Permit Number: 100762

has permission to Erect freestanding and attached building wall signs total of 10 sq ft City of Portland

<b>Dept:</b> Historic	<b>Status:</b> Approved with Conditions	<b>Reviewer:</b> Deborah Andrews	<b>Approval Date:</b> 07/08/2010
<b>Note:</b>			<b>Ok to Issue:</b> ✓

Sheet Number **S15-P.1** Rev. \_\_\_\_\_

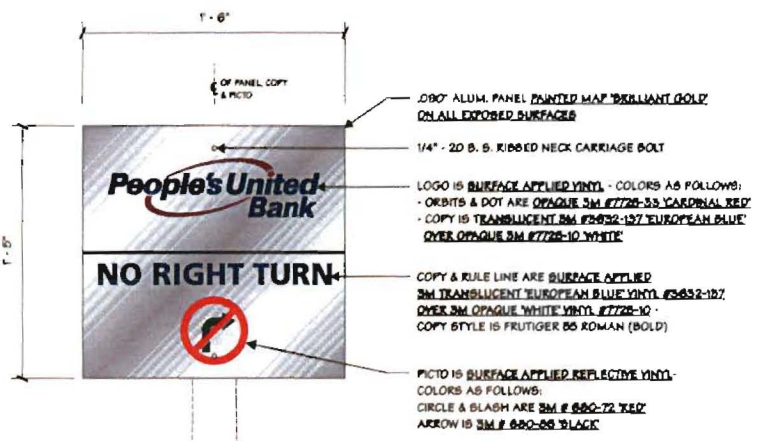
no logo. per Deb Anderson

Sheet Number **D1-1** Rev. \_\_\_\_\_

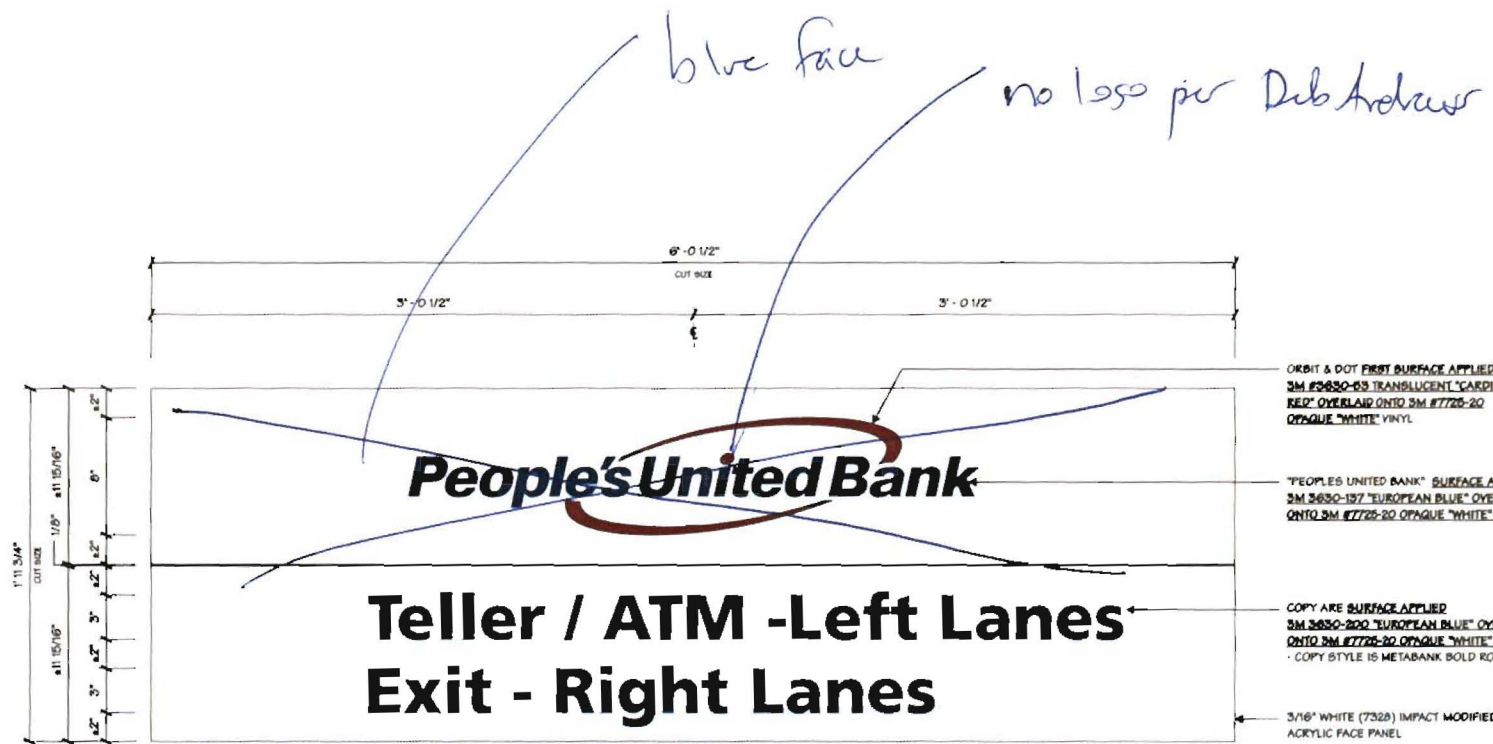
1) * Signs D1.1 and P 1.1 shall exhibit directional information only--no commercial content			
* All signs proposed with white vinyl faces shall be revised to feature opaque blue aluminum faces with white vinyl letters and red vinyl ellipse. (In those cases where the existing signs feature internal illumination, the new signs may be routed for lit graphics, but sign faces shall be opaque metal).

Sheet Number **W7-2** Rev. \_\_\_\_\_

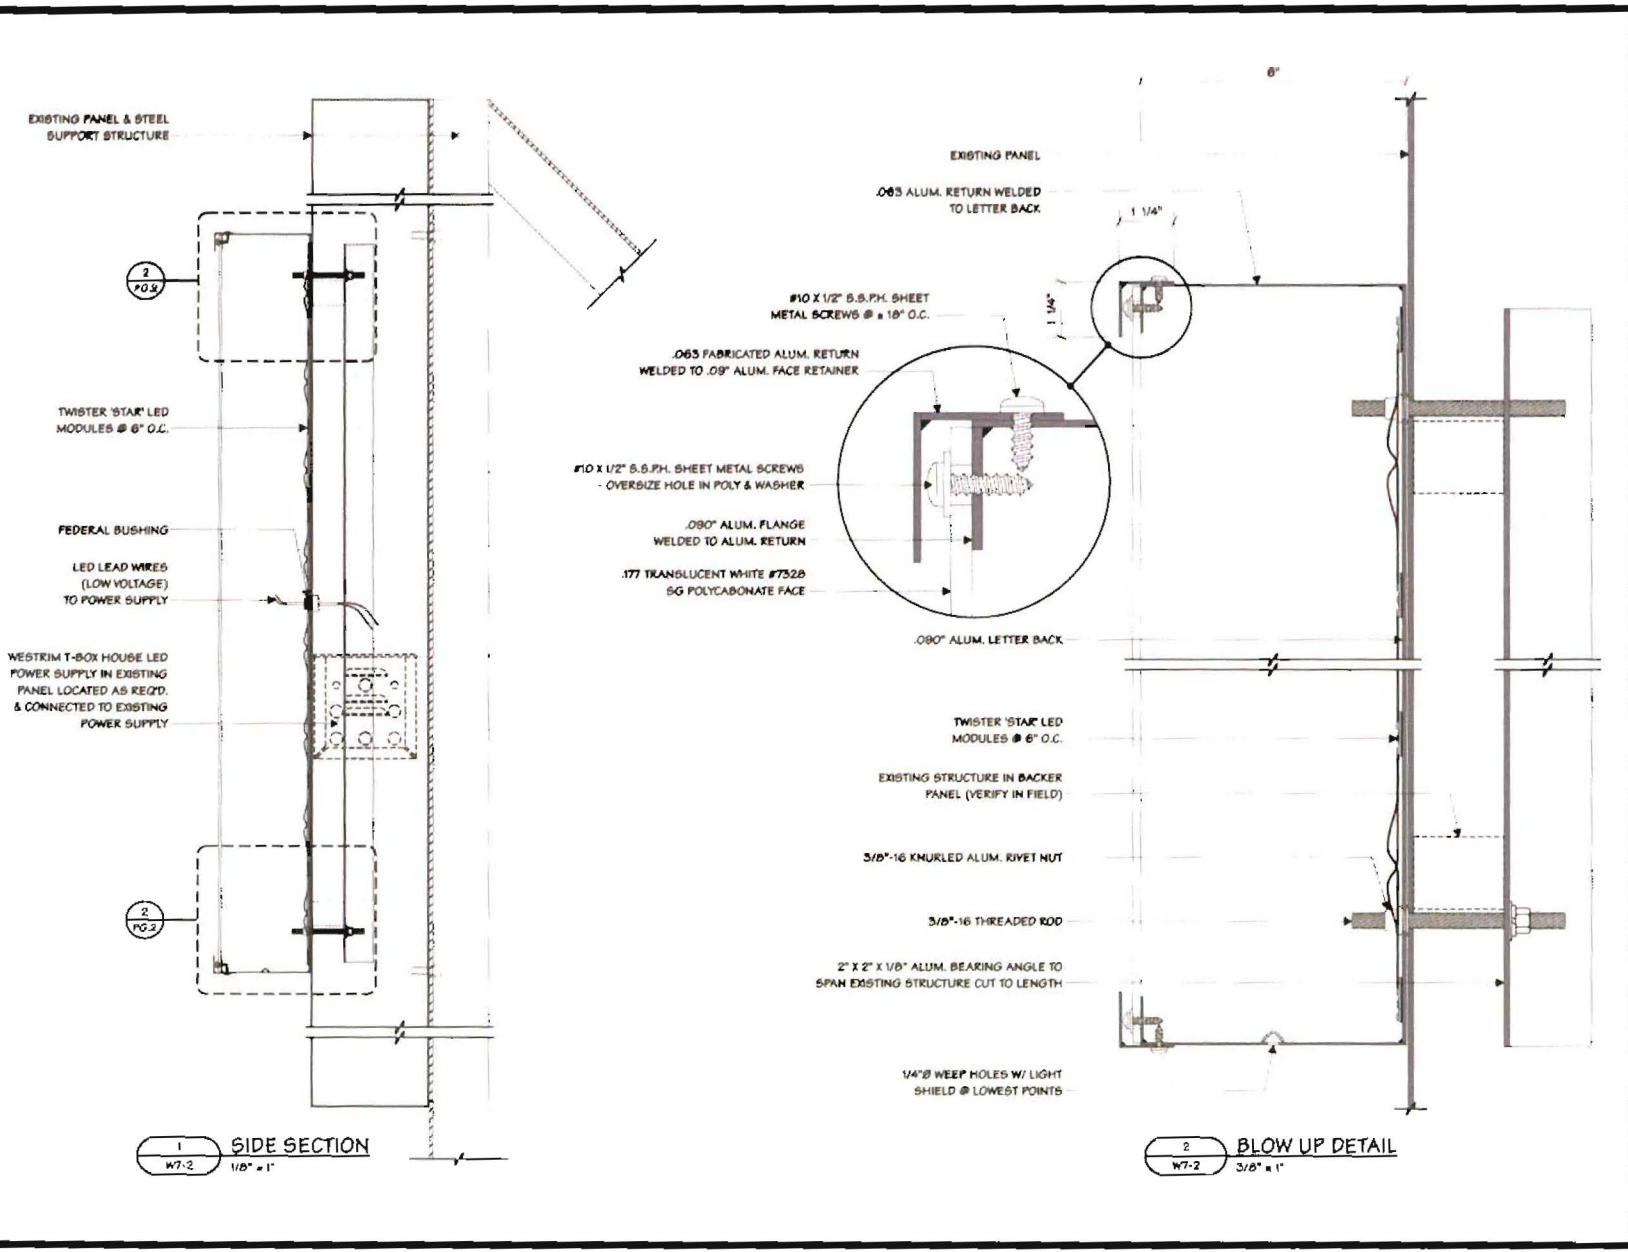
* In no event shall any signs exceed the size of the existing signs. Also, the overall height of the new rooftop sign shall not exceed that of the existing sign.			
<b>Dept:</b> Zoning	<b>Status:</b> Approved	<b>Reviewer:</b> Ann Machado	<b>Approval Date:</b> 07/08/2010
<b>Note:</b> Gave permit to Deb Andrews under section 14-368.5(g). The two "roof" signs were permitted under permit #950867. The two pylon signs and the sign in the rear were permitted under permit #961137. The aluminum canopy on Congress Street was permitted under a permit in 1980 and permit #913077. The four sign plaques along the front of the building were not permitted and don't meet the ordinance. Deb approved the signs on 7/8/10.			<b>Ok to Issue:</b> ✓
<b>Dept:</b> Building	<b>Status:</b> Approved with Conditions	<b>Reviewer:</b> Tammy Munson	<b>Approval Date:</b> 07/16/2010
<b>Note:</b>			<b>Ok to Issue:</b> ✓

permit 95-0867  
 sign was 74'x  
 this is 61'x

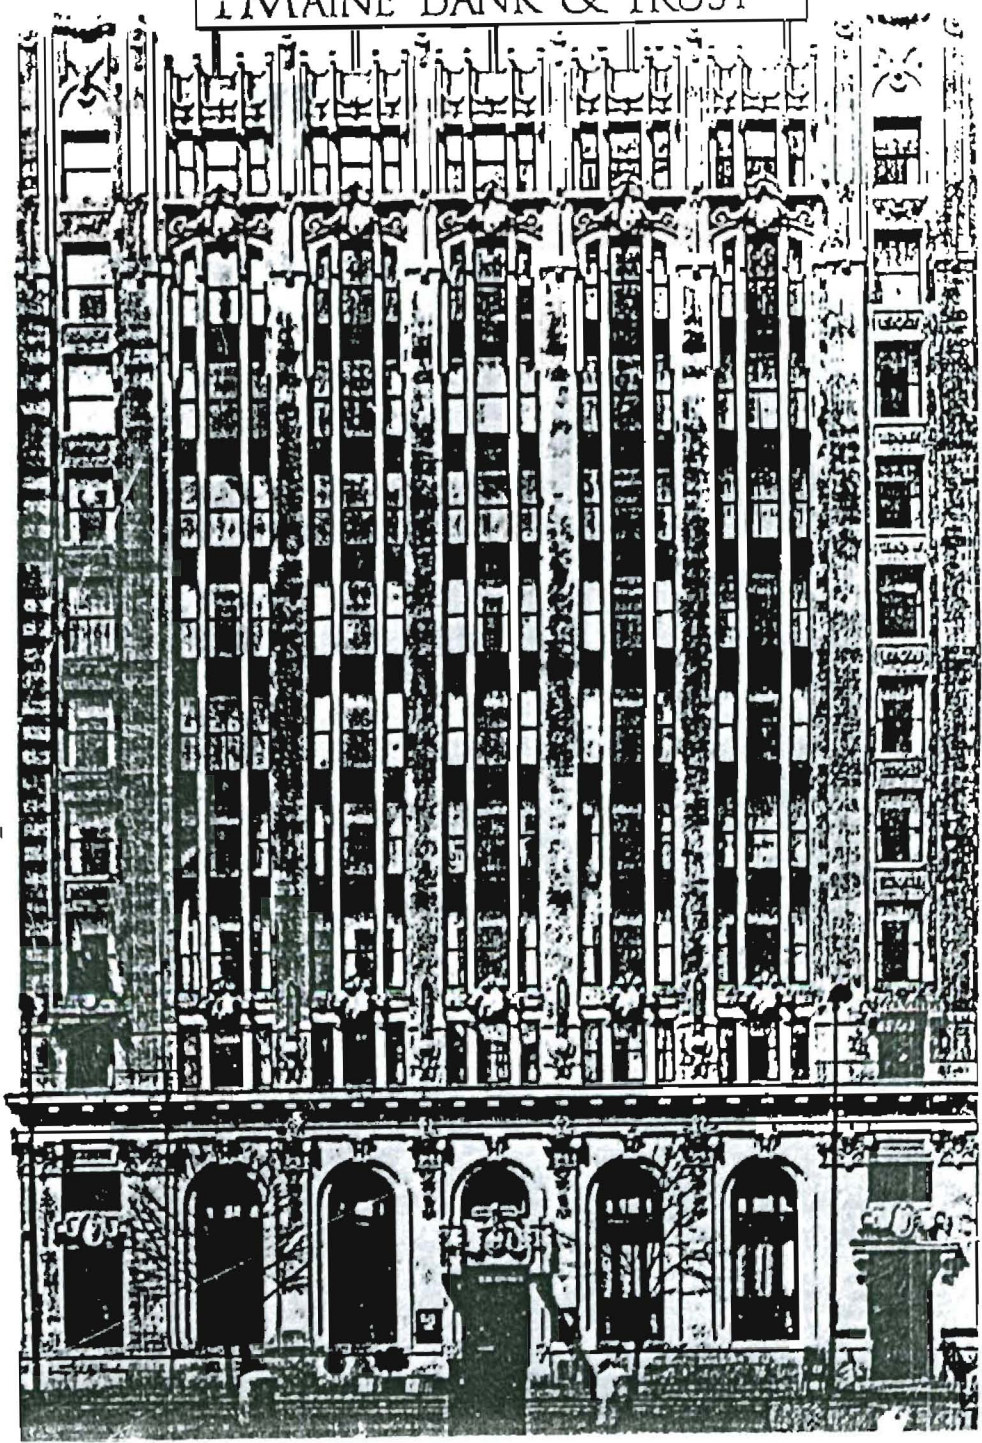
This is Not A Roof Sign -  
IT is on Existing Bldg -

170 high? x 96' = 16320'²

170 x 82 = 13940'²

OK
